## **Main Injector Electronics**

### **Electrical Schematic of the Beam Position Monitor Transition Board Control Module**

**Document # Beam-doc-2154-v1**

MI BPM TB Control Module HARDWARE CHANGES

**RAM,LEMO,ROTARY**

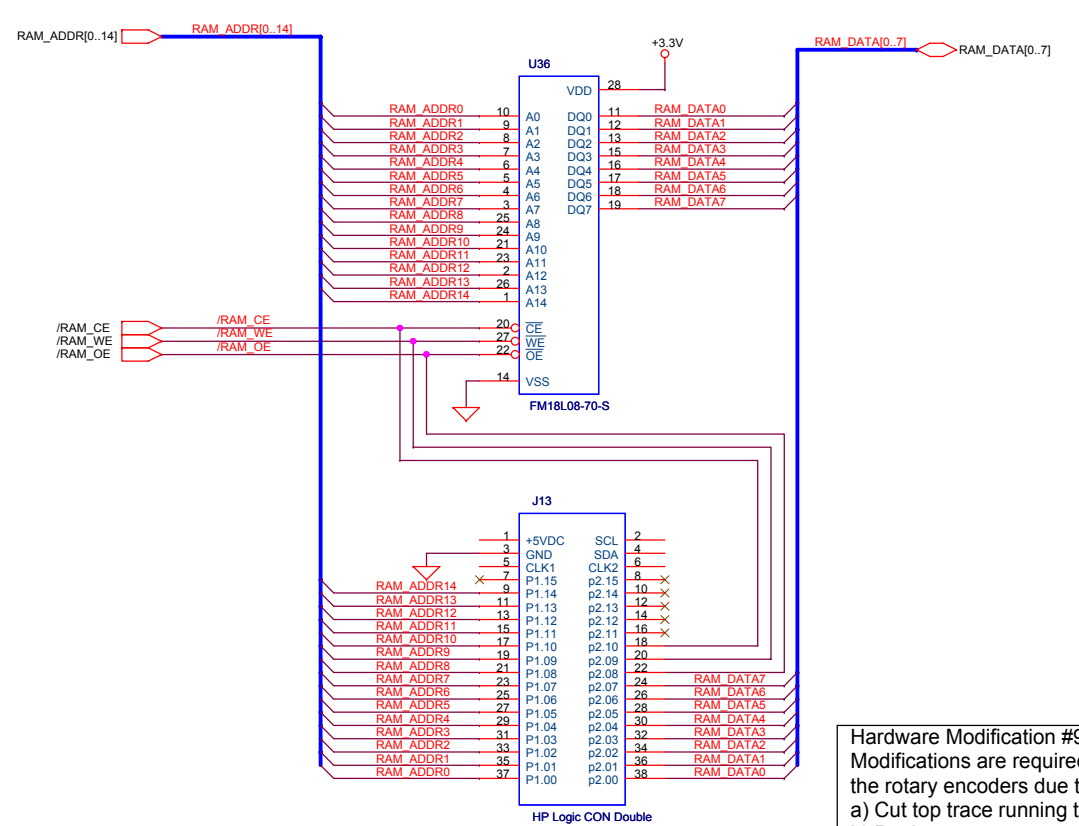
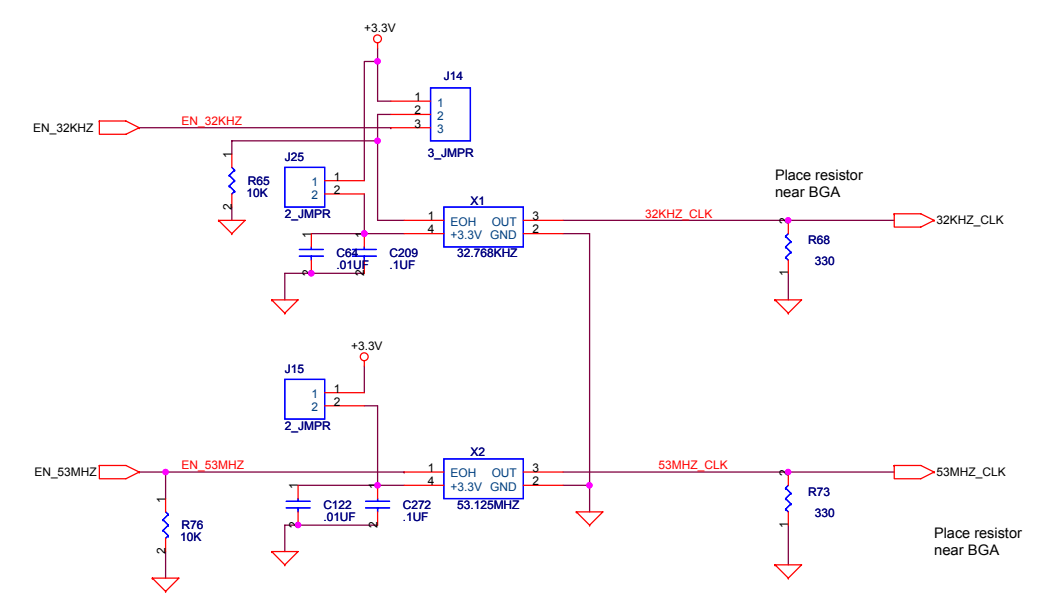
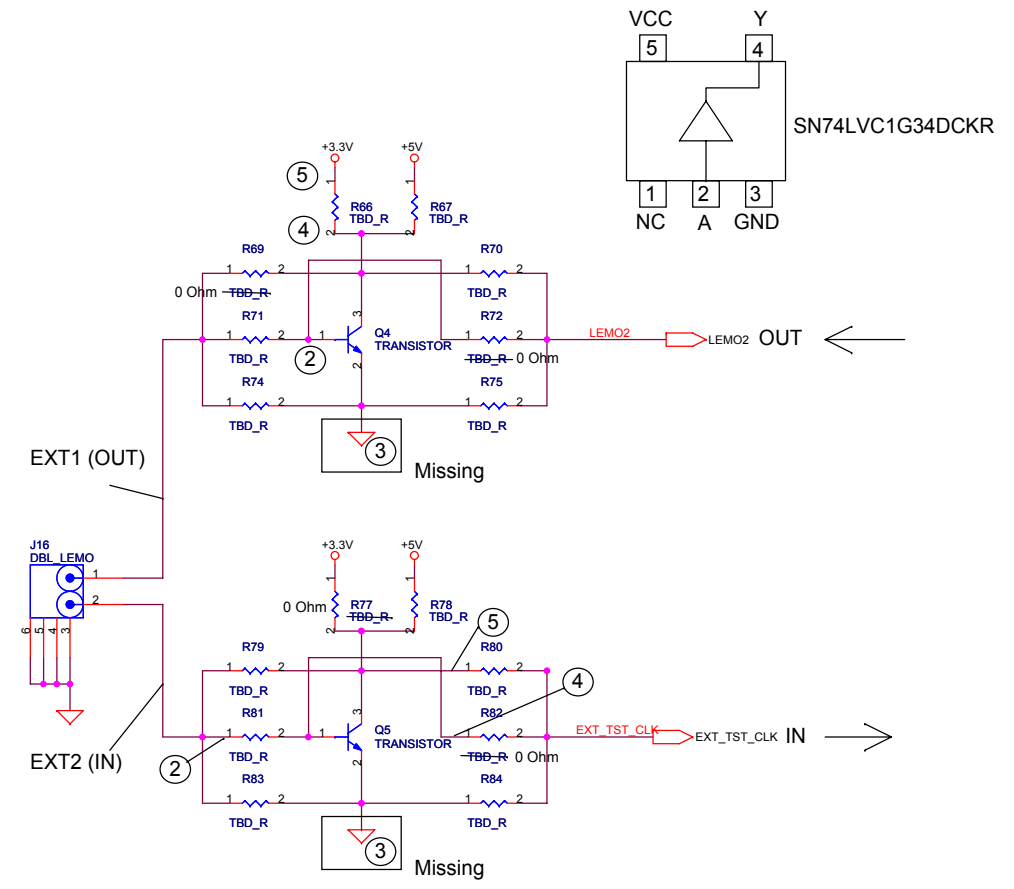
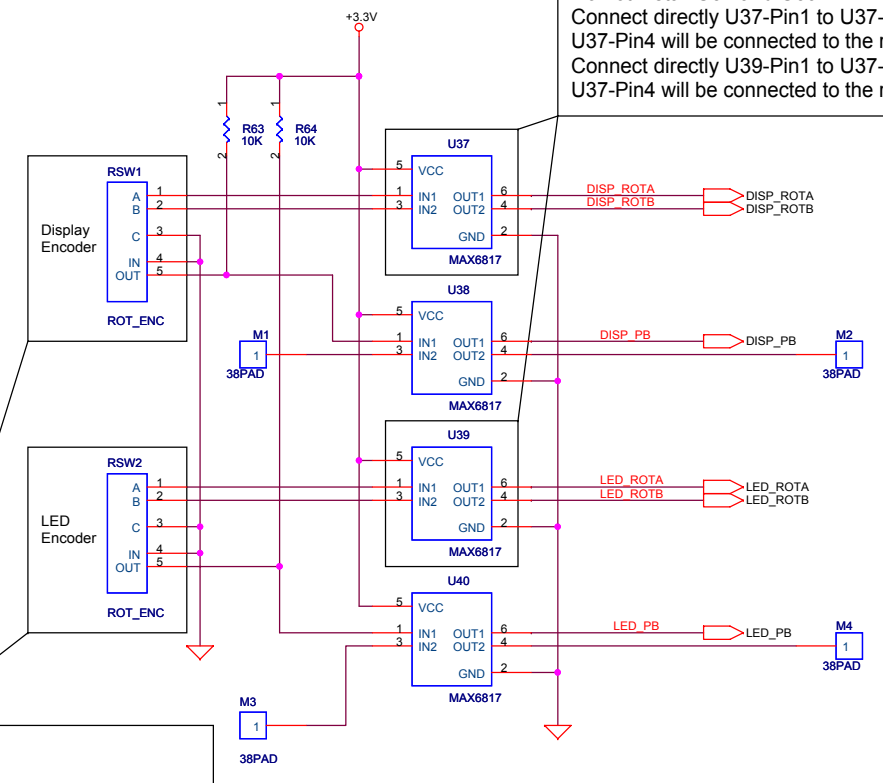
**Hardware Modification OPT#B:**  
 Add components positioned at Q4 and Q5 to enable external test signal input (LEMO EXT2) and test signal monitoring (LEMO EXT1).  
 It requires firmware revision of December 13, 2006 or later.

**Hardware Modification #9:**  
 Modifications are required before installing the rotary encoders due to error in footprint.  
 a) Cut top trace running to pin 2 on PCP.  
 b) Put kapton tape over pin 3 hole on top side of PCB.  
 c) Bend pin 3 of rotary encoder towards rear of switch.  
 d) Solder black wire wrap wire (about 3") to pin 3 of rotary encoder.  
 e) Install rotary encoder  
 f) Solder other end of black wire wrap wire to pin 4 pad of associated MAX6817, U39 for RSW2 and U37 for RSW1.

**Hardware Modification #8:**  
 Do not install U37 and U39.  
 Connect directly U37-Pin1 to U37-Pin6.  
 U37-Pin4 will be connected to the rotary encoder with a wire in modification #9.  
 Connect directly U39-Pin1 to U39-Pin6.  
 U39-Pin4 will be connected to the rotary encoder with a wire in modification #9.

**TIMING MODULE INTERFACE**

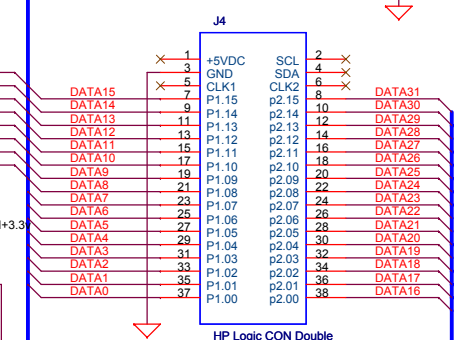
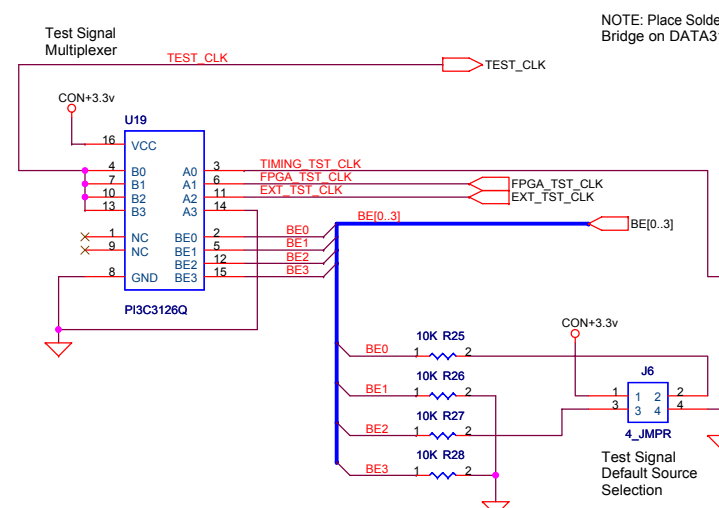
**Hardware Modification #14:  
Place Solder Bridge on DATA31**

Title		
BPM Transition Board Control Module		
Size	Document Number	Rev
C	Beam-doc-2154	A
Date:	Tuesday, January 09, 2007	Sheet 10 of 10

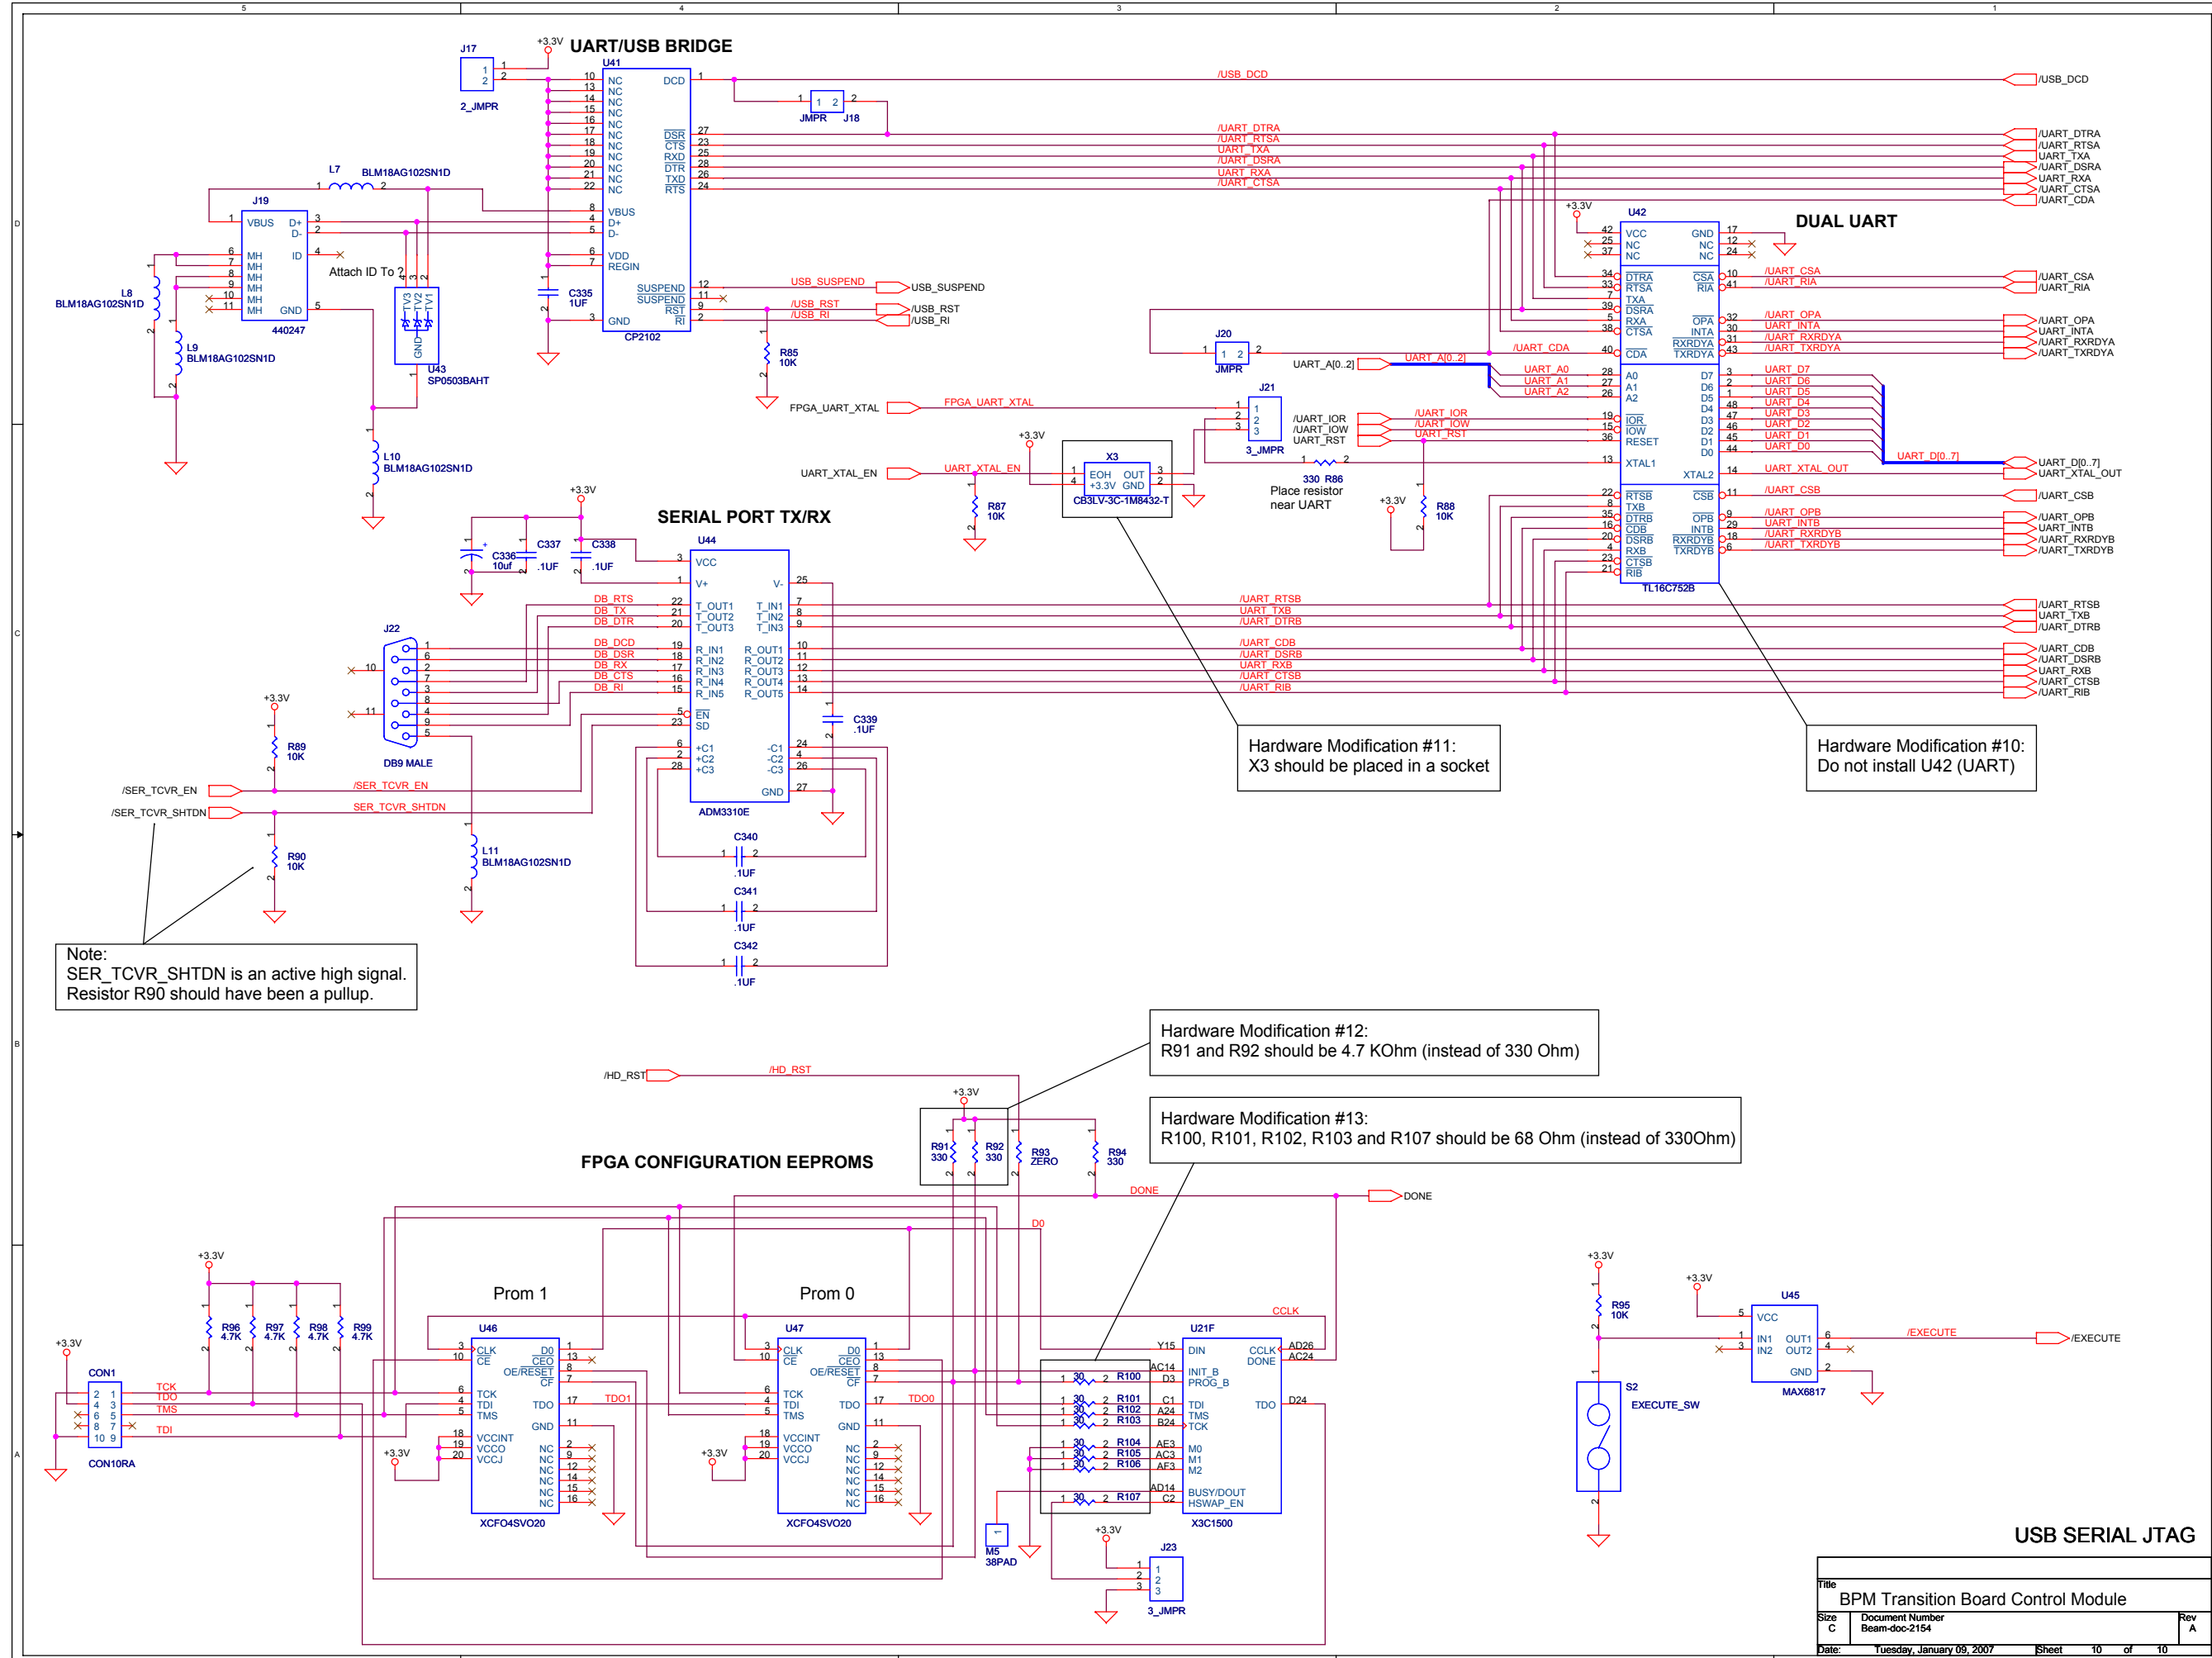
Note:  
SER\_TCVR\_SHTDN is an active high signal.  
Resistor R90 should have been a pullup.

Hardware Modification #11:  
X3 should be placed in a socket

Hardware Modification #10:  
Do not install U42 (UART)

Hardware Modification #12:  
R91 and R92 should be 4.7 KOhm (instead of 330 Ohm)

Hardware Modification #13:  
R100, R101, R102, R103 and R107 should be 68 Ohm (instead of 330Ohm)
